INNER WEST COUNCIL

DEVELOPMENT ASSESSMENT REPORT

Application No.	D/2017/18
Address	12 Reuss Street, BIRCHGROVE NSW 2041
Proposal	Construction of a double garage with studio above at rear of site fronting Water Street
Date of Lodgement	19 January 2017
Applicant	Mr P J Fitzgerald
Owner	Mr P J Fitzgerald and Mrs S L Fitzgerald
Number of Submissions	One (1) objection
Value of works	\$145,000
Reason for determination at Planning Panel	Clause 4.6 variation exceeds officer delegation
Main Issues	Streetscape FSR, Landscape and Site Coverage non-compliance Amenity
Recommendation	Approval

Figure 2: Site Plan showing the BLZ established by the adjoining buildings at No. 10 Reuss Street and No. 5A Water Street, as well as the relationship of the proposed garage/ studio development on the subject site.

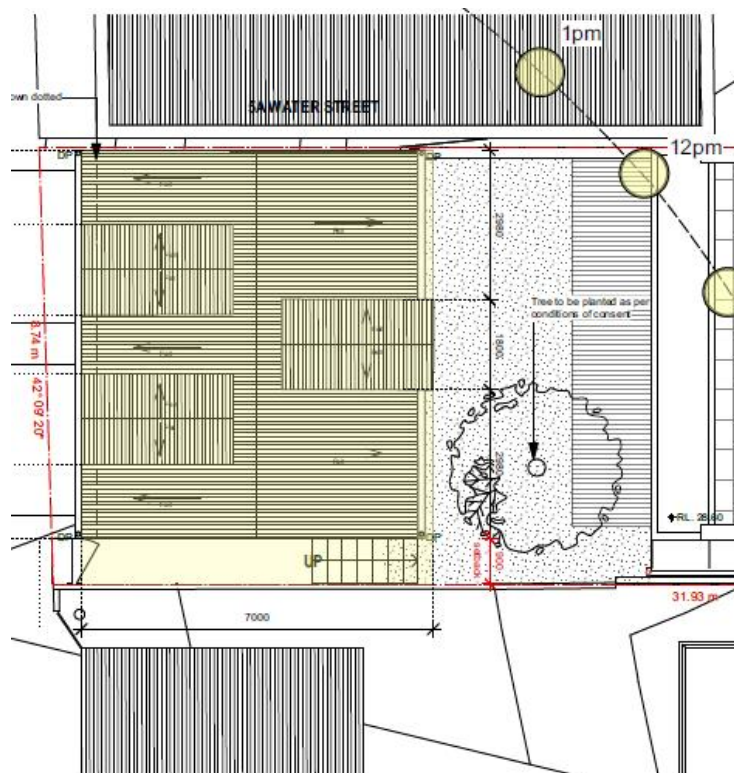
Building Location Zones:

The proposed garage structure projects beyond the rear alignment of the garage structure at No. 10 Reuss Street, but is well setback behind the rear alignment of the 2 storey building at No. 5A Water Street (see Figure 2 below). Accordingly, the proposal complies with Council's BLZ controls.

Figure 3: Solar Access diagram (3pm mid-winter) prepared by Utz Sanby Architects.

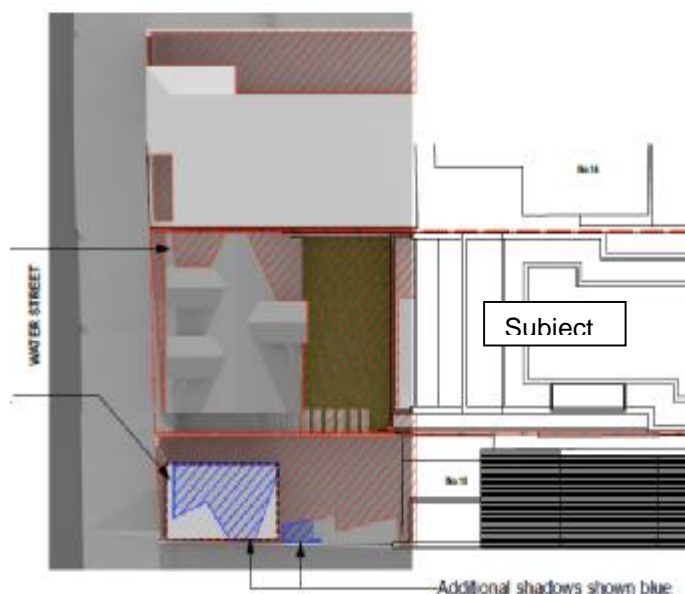
The proposed garage structure is unlikely to result in additional overshadowing at 9am and 12noon mid-winter. However, there will be a minor increase in additional overshadowing at 3pm, measuring approximately 1m² in area (see Figure 3 - Solar Access plan below).

While subclause C19 states that "Where surrounding dwellings currently receive less than the required amount of solar access to their private open space between 9am and 3pm during the winter solstice, no further reduction of solar access is permitted", the increase in additional overshadowing is minor; is likely to result between 2-3pm only; and is within the area adjoining the existing garage at No. 10 Reuss Street rather than the area immediately adjoining the rear living room of No. 10. Accordingly, given the aforementioned the proposal is considered acceptable in regards to solar access.
